STANDARD DEPARTURE CHART - INSTRUMENT

RJNH / HAMAMATSU

KOWA SIX DEPARTURE

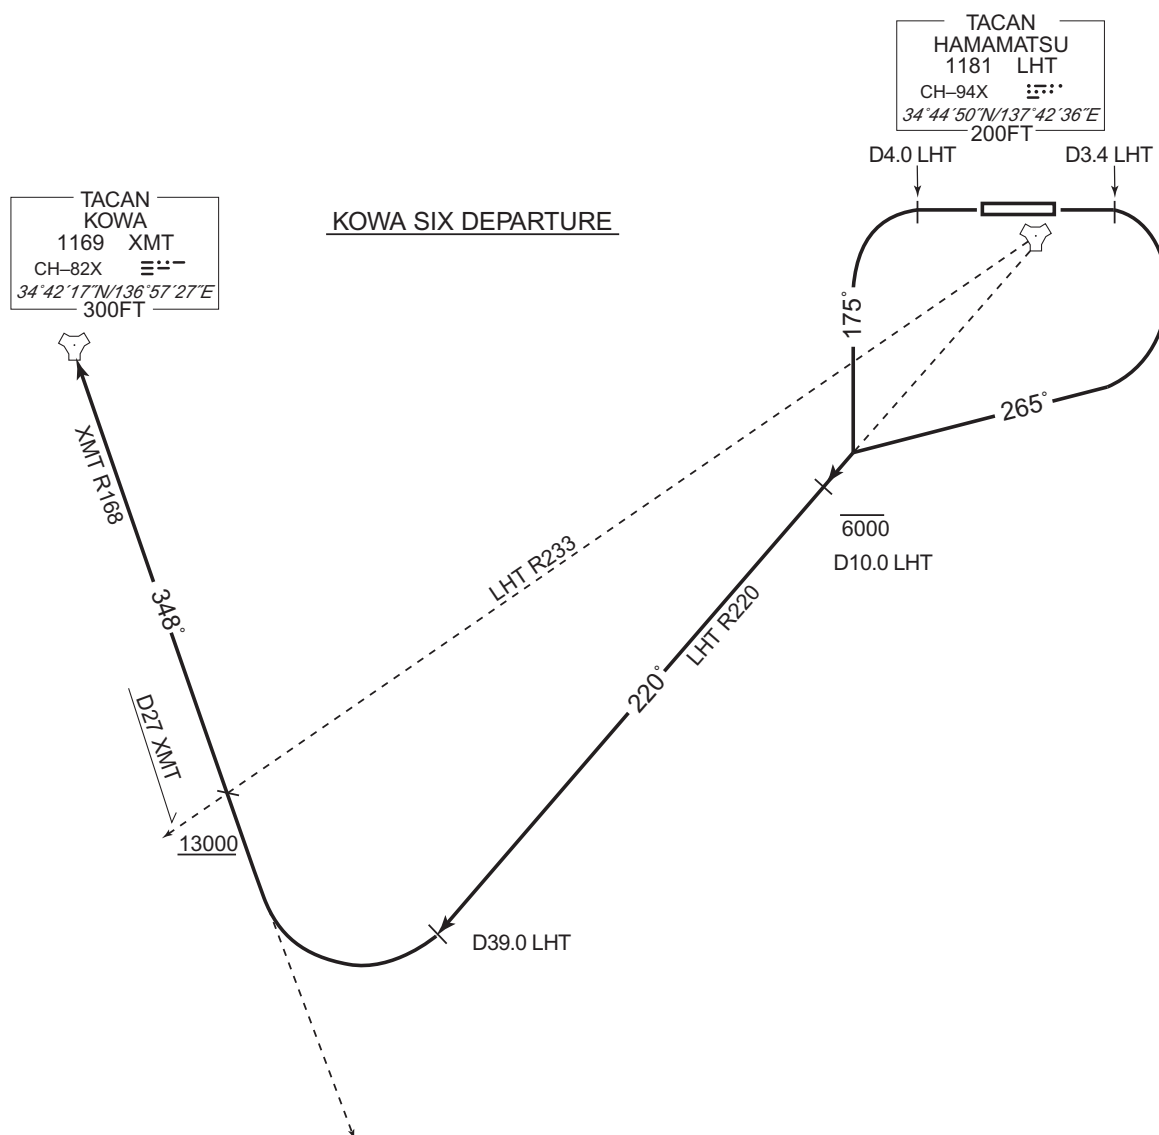
CHANGE : PROC renamed. PROC course. Note deleted.

ATSUMI FIVE DEPARTURE

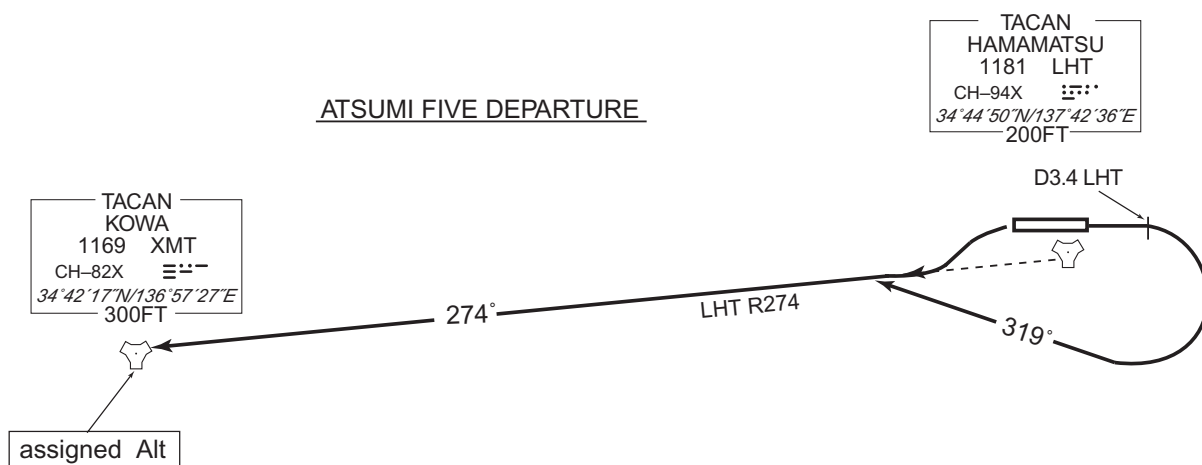
CHANGE : PROC renamed. PROC course. Note deleted.

HAMAMATSU REVERSAL THREE DEPARTURE

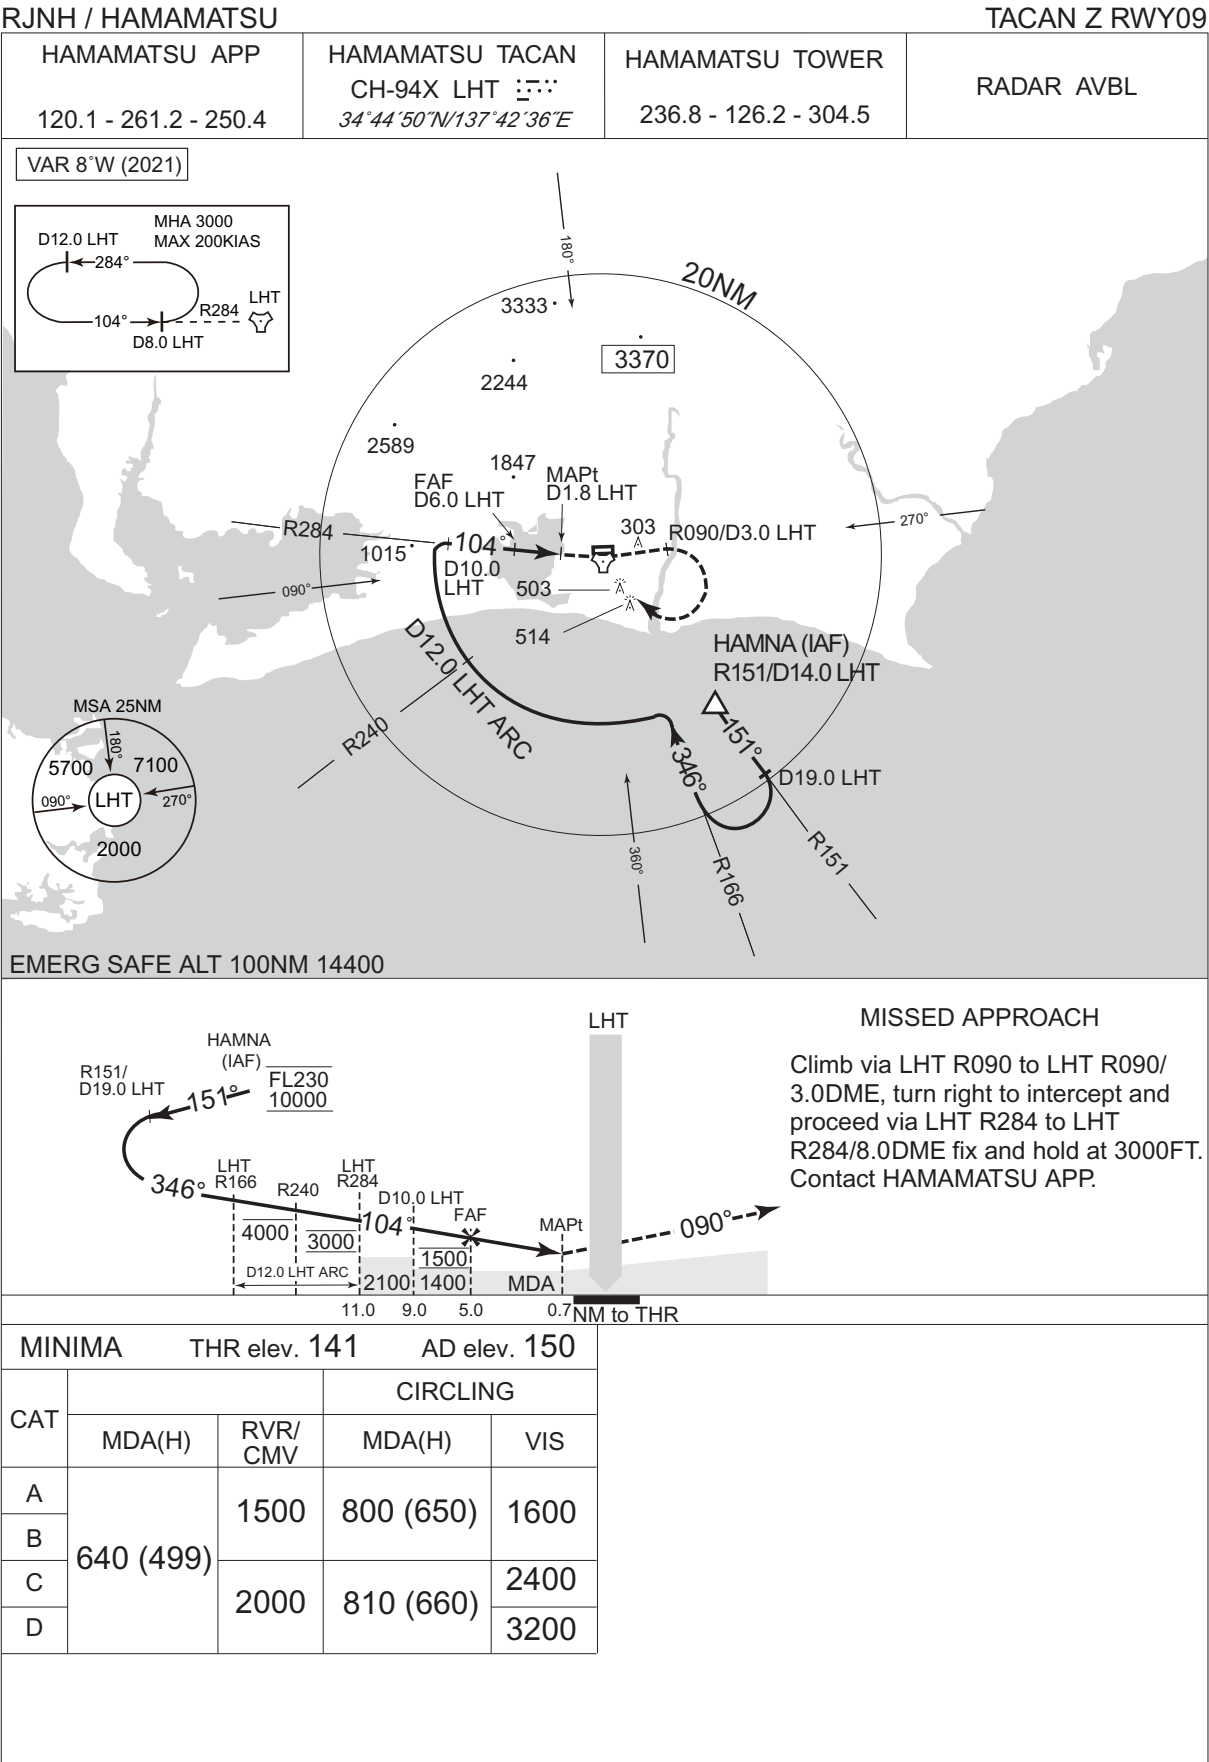
CHANGE : PROC renamed. PROC course. Note deleted.

TACAN Y RWY09

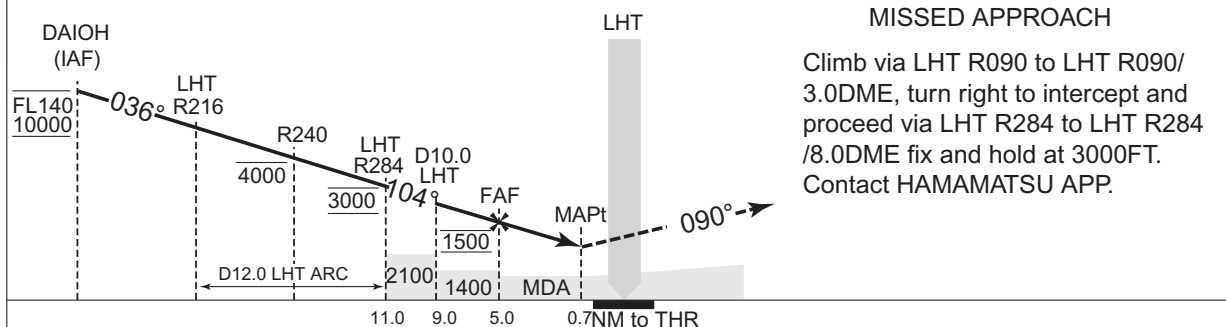
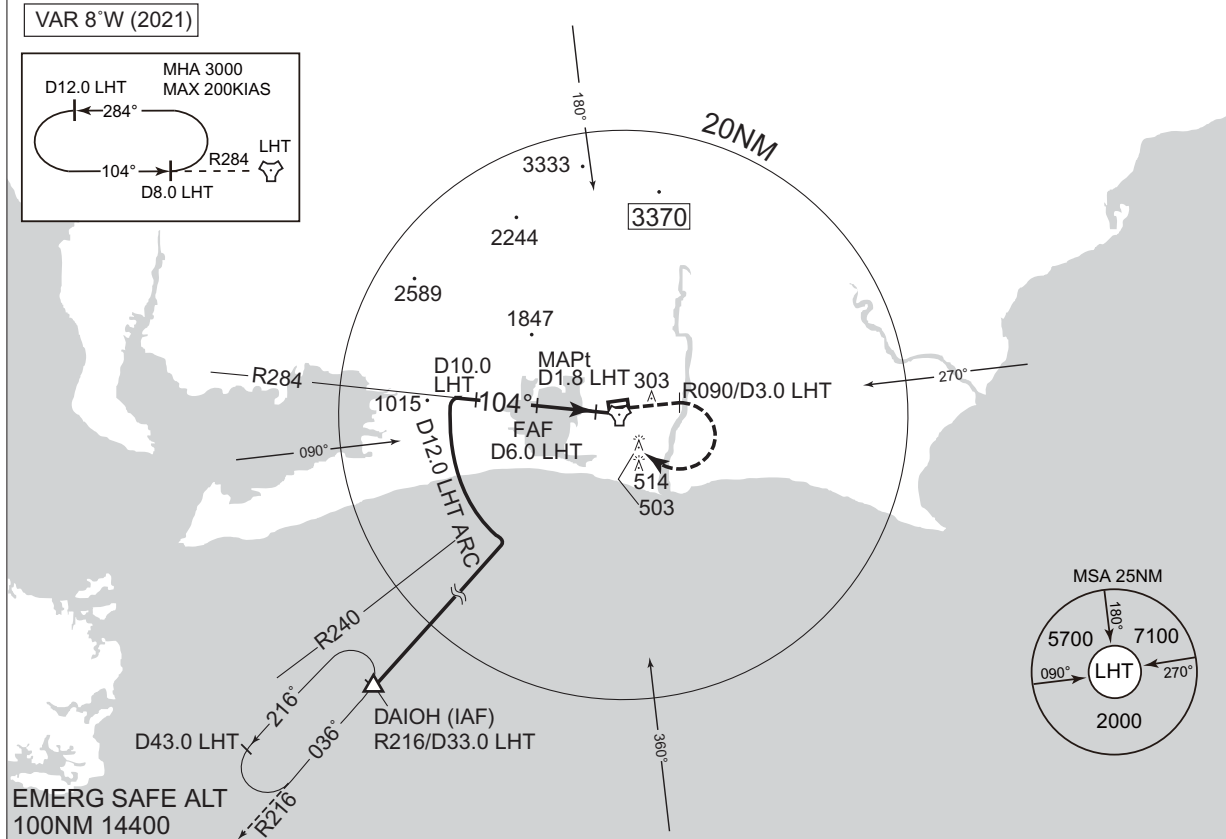
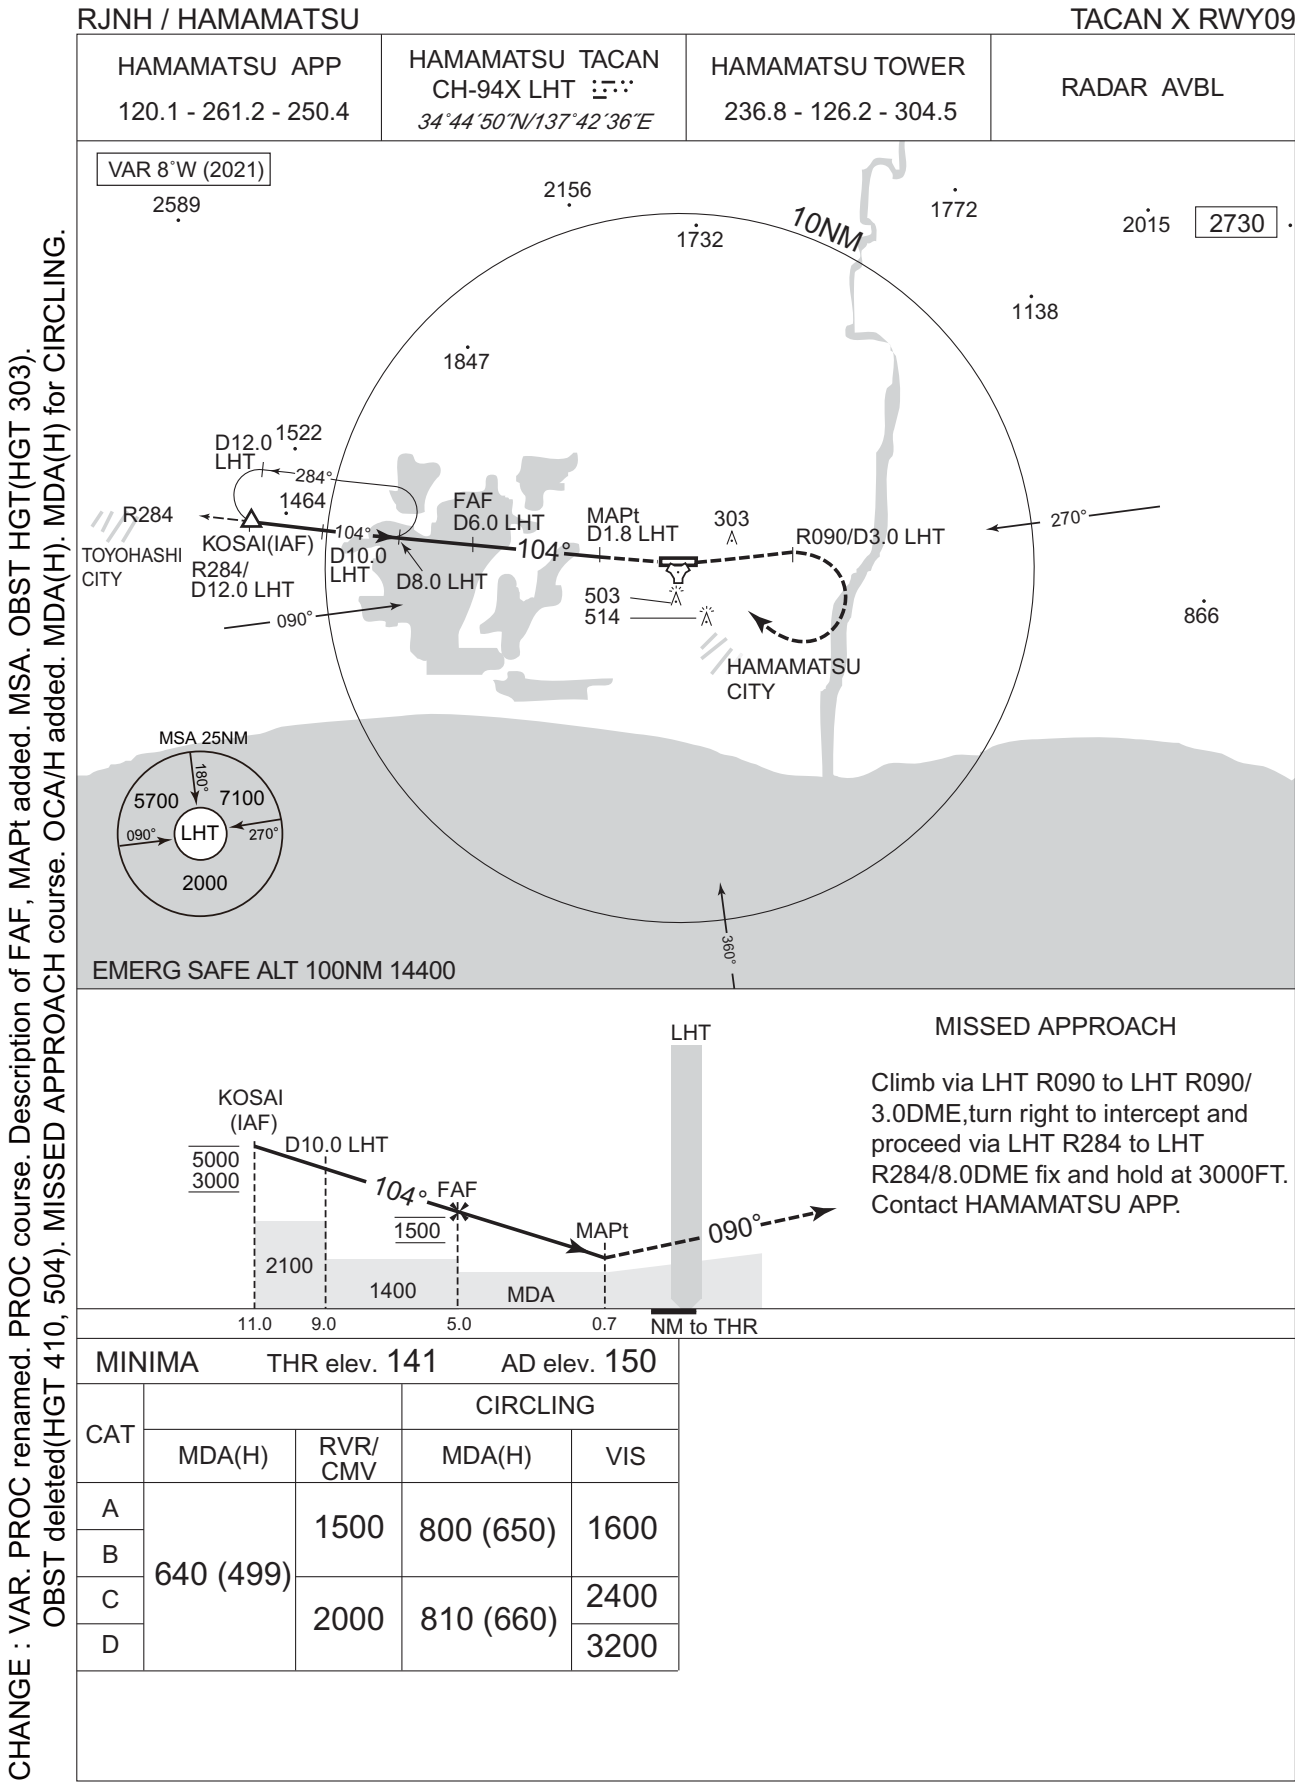
CHANGE : VAR. PROC renamed. PROC course. Description of FAF, MAPt added. MSA. HLDG pattern added. OBST added(HGT 303).
OBST deleted(HGT 410, 504). MISSED APPROACH course. OCA/H added. MDA(H). MDA(H) for CIRCLING.

TACAN Z RWY27

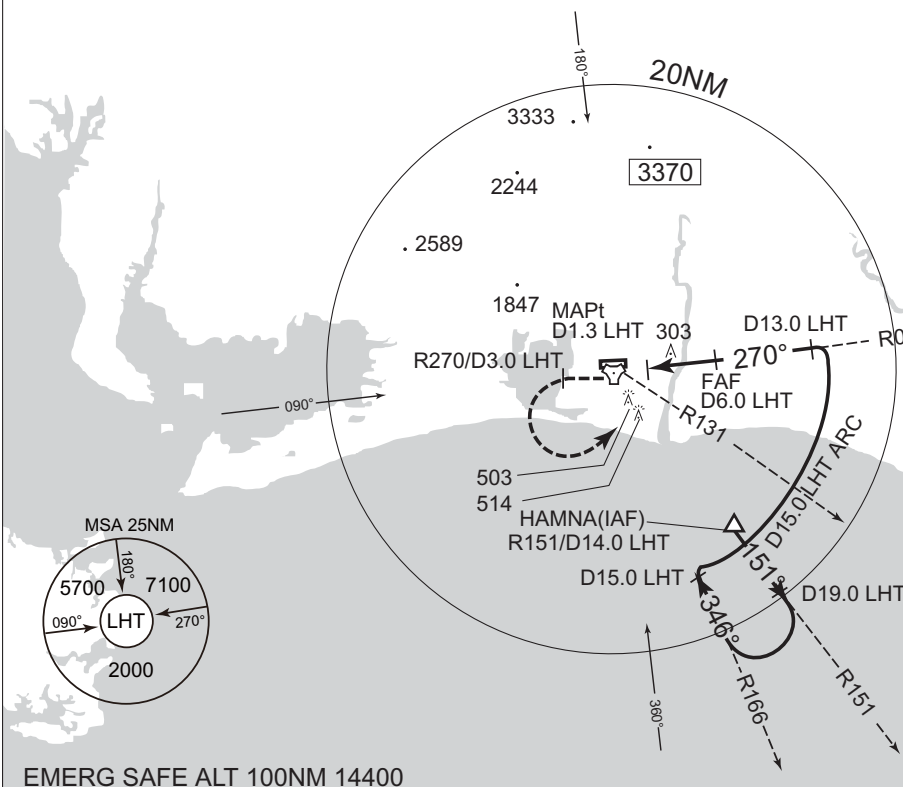
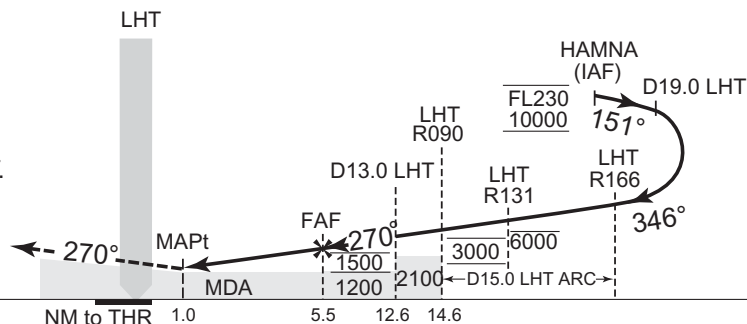
CHANGE : VAR. PROC renamed. PROC course. Description of FAF, MAPt added. OBST added(HGT 303).
OBST deleted(HGT 410, 504). MISSED APPROACH course. ALT restriction(LHT R090). OCA/H added. MDA(H). MDA(H) for CIRCLING.
